SHOPS AT MCLAUGHLIN II

7368 McLaughlin Road, Peyton CO 80831

PRELIMINARY
GRADING
PLAN
9 OF 12

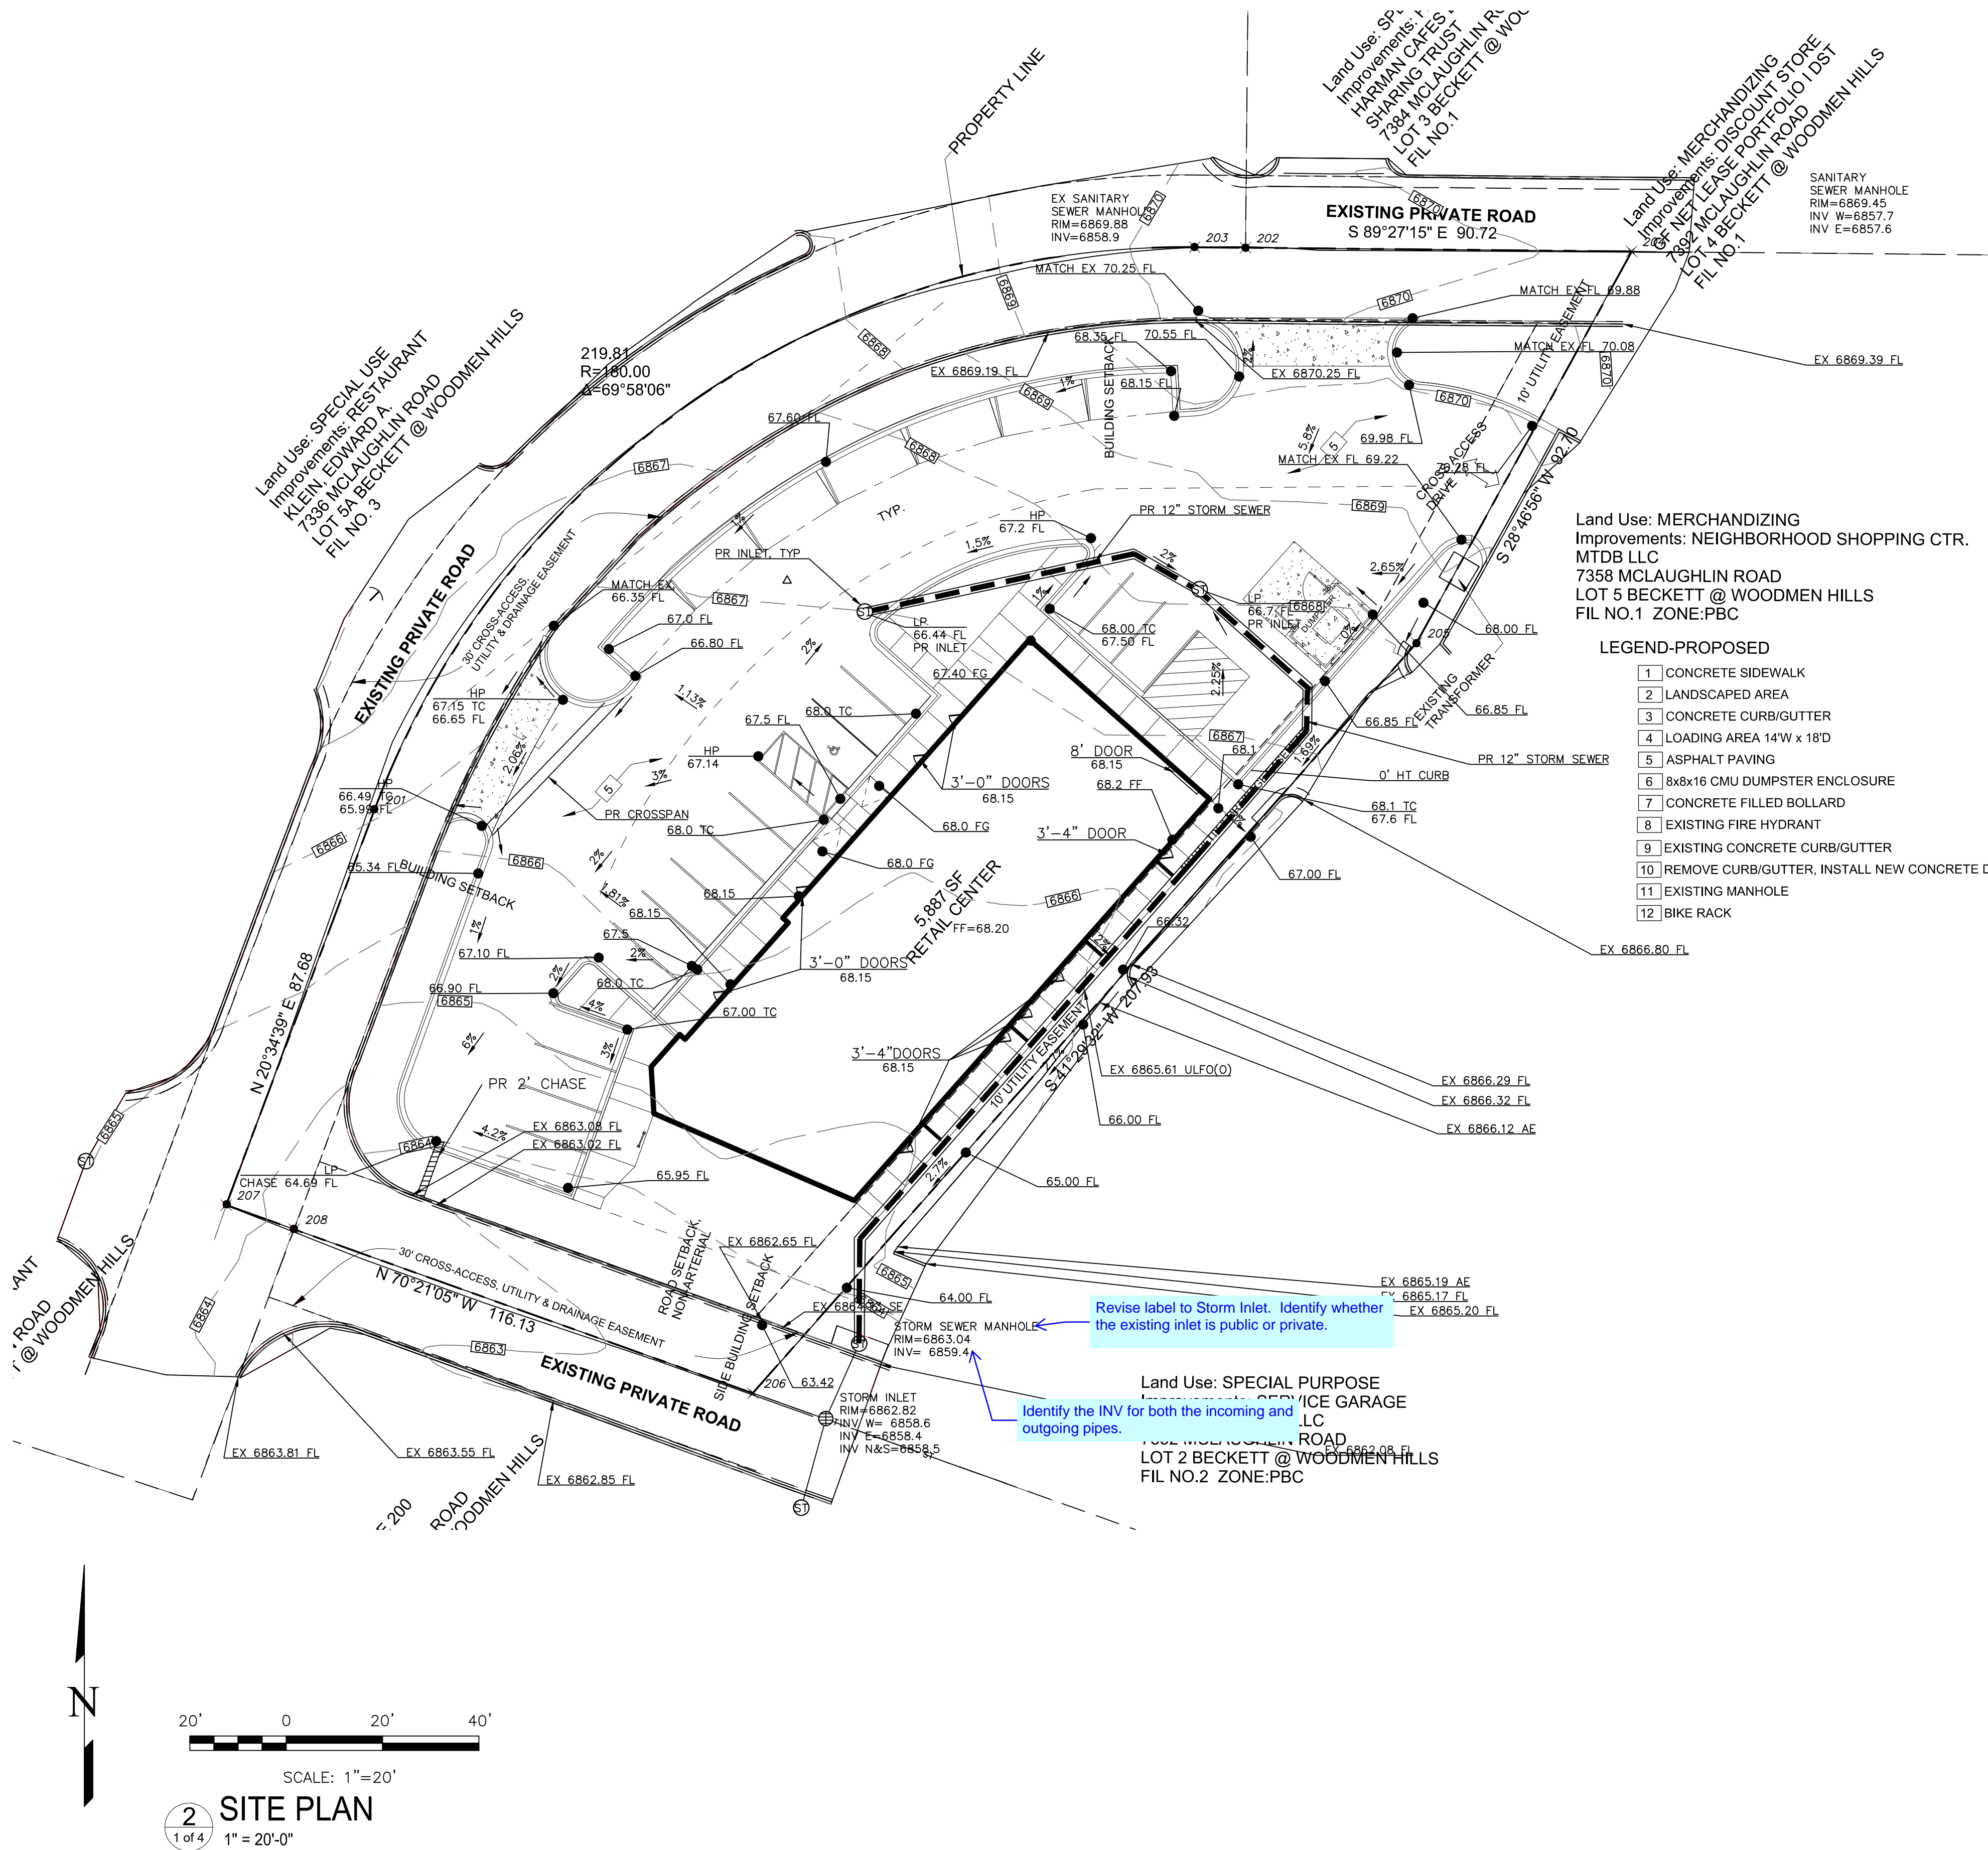
The erosion control map was not included with the submittal.

On the resubmittal. Submit a Grading and Erosion Control Plan (GEC) as a standalone plan set.

Include a cover page with the standard GEC Notes, signature blocks, vicinity map, etc. (see ECM Appendix E for Grading and Erosion Control Plan submittal checklist).

Submit the associated Financial Assurance Estimate Form for the cost of the Erosion Control BMPs.

Add "PCD File No. PPR-17-055" at the bottom right of the cover sheet of the standalone Grading and Erosion Control Plan.

Revise label to Storm Inlet. Identify whether the existing inlet is public or private.

Identify the INV for both the incoming and outgoing pipes.
